APPLICATION FOR URBAN DESIGN COMMISSION REVIEW AND APPROVAL

Re: Presentation to UDC PUD-SIP 1254 Willamson Street

Project Title Baldwin Corners 1254 Williamson Street

Drawing No. C-1.1a

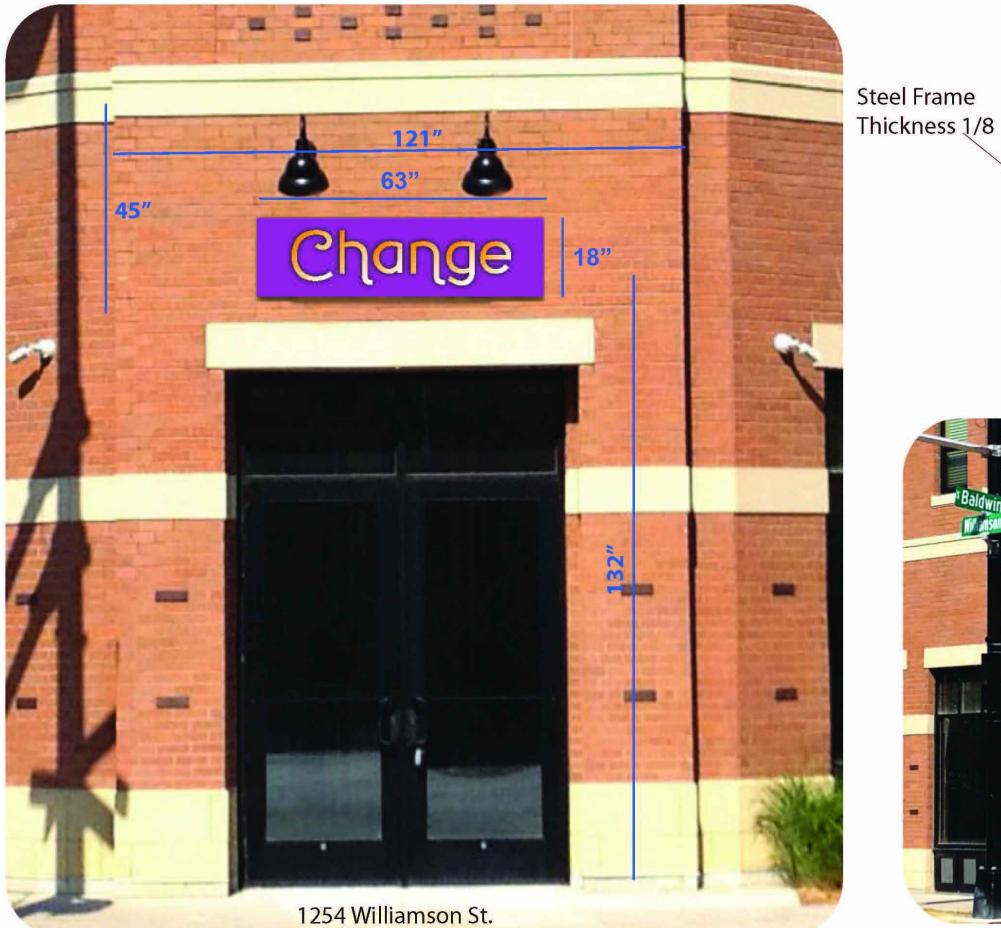
The sign is made of 1.5" wood board with the name CHANGE as a recessed cutout of 0.5" and painted violet. It has a steel frame skeleton which attaches to the brick facade. The sign does not light from within. The sconces above will contain incandescent bulbs pointed at the sign with no glare or interference to passing traffic.
